KIAWAH RIVER PLANTATION (KRP) WASTEWATER TREATMENT PLANT (WWTP)

T&H PROJECT NO.
J-25328

ADDENDUM NO. 3

March 24, 2016

9 Door Jamb
Scale: NTS

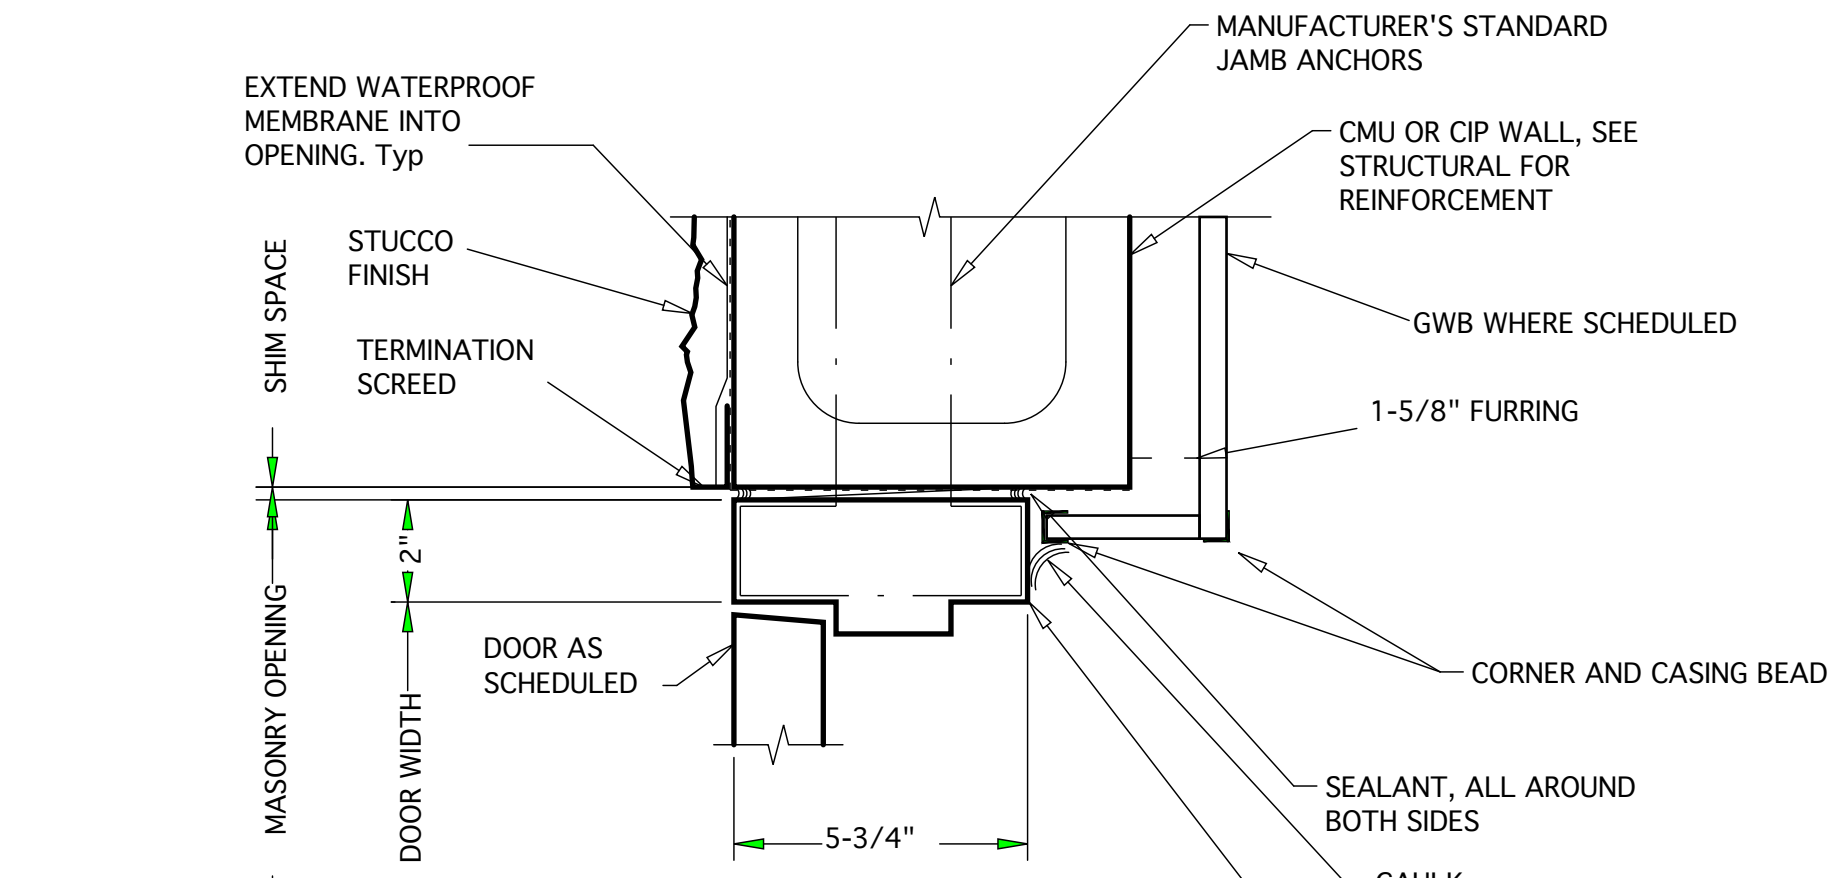
2. Drawings 35-A-18 and 35-A-19 include details for the installation of the doors and louvers in CMU and metal stud walls. Can you provide details for doors and louvers installed in cast-in-place concrete locations (i.e. lower level of Waste Water Treatment Facility on Drawing 35-A-10)?

Answer: See Revised Sheet 35-A-18 included with this addendum.
